UNITED STATES  
NUCLEAR REGULATORY COMMISSION  
WASHINGTON, D. C. 20555

KEWAUNEE NUCLEAR POWER PLANT

Amendment No. 76  
License No. DPR-43

SAFETY EVALUATION BY THE OFFICE OF NUCLEAR REACTOR REGULATION  
RELATING TO AMENDMENT NO. 76 TO FACILITY OPERATING LICENSE NO. DPR-43

Application of Plugging Limits  
Figure TS 4.2-1

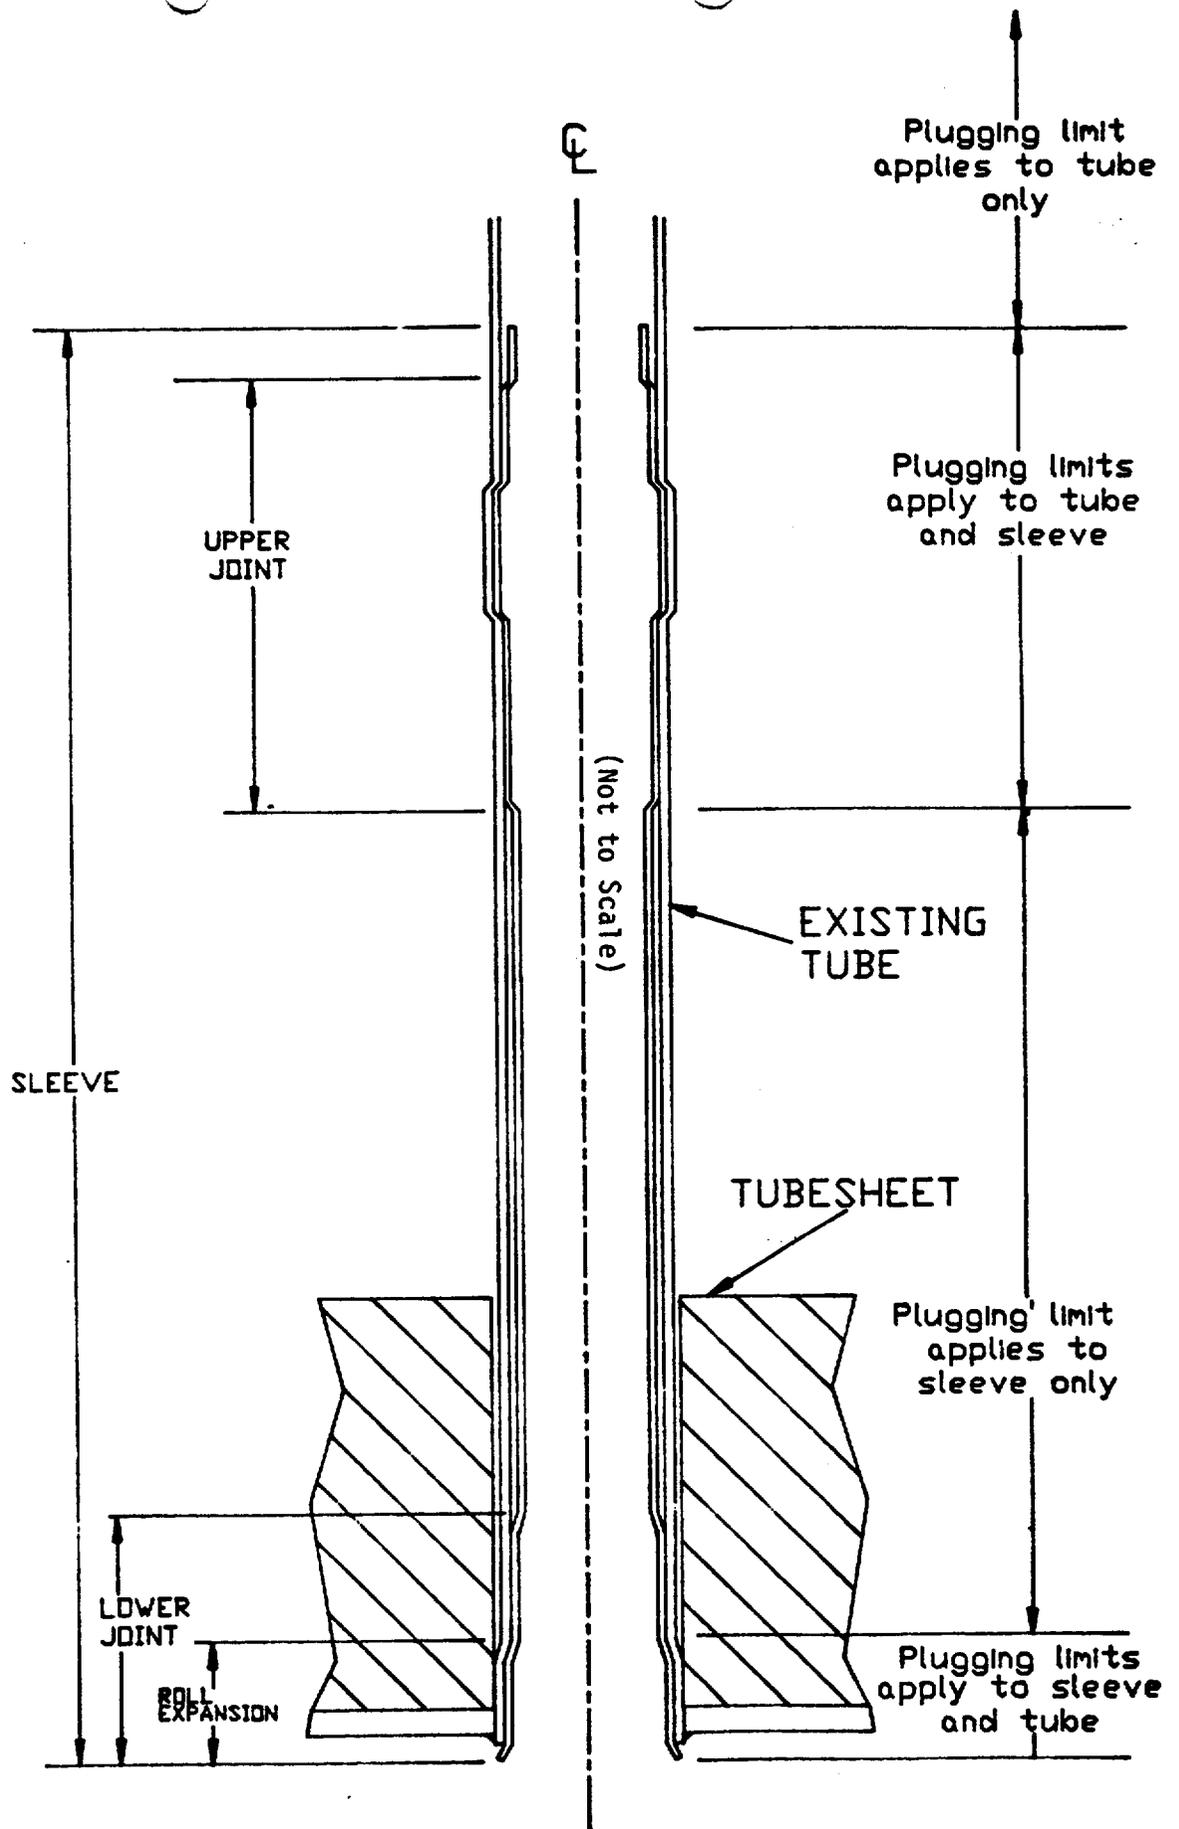
- b. Any sleeve which, upon inspection, exhibits wall degradation of 31% or more shall be plugged prior to returning the steam generator to service. Figure 4.2-1 illustrates the application of tube, sleeve, and tube/sleeve joint plugging limit criteria.

4. Plugging Limit Criteria - The following criteria apply independently to tube and sleeve wall degradation:
- a. Any tube which, upon inspection, exhibits tube wall degradation of 50% or more shall be plugged or repaired prior to returning the steam generator to service. If significant general tube thinning occurs, this criterion will be reduced to 40% wall degradation. Repair methods will be submitted under 10 CFR 50.90 to be incorporated, as an amendment, in the facility license. The Commission will review the repair method, issue a significant hazards determination, and amend the facility license.
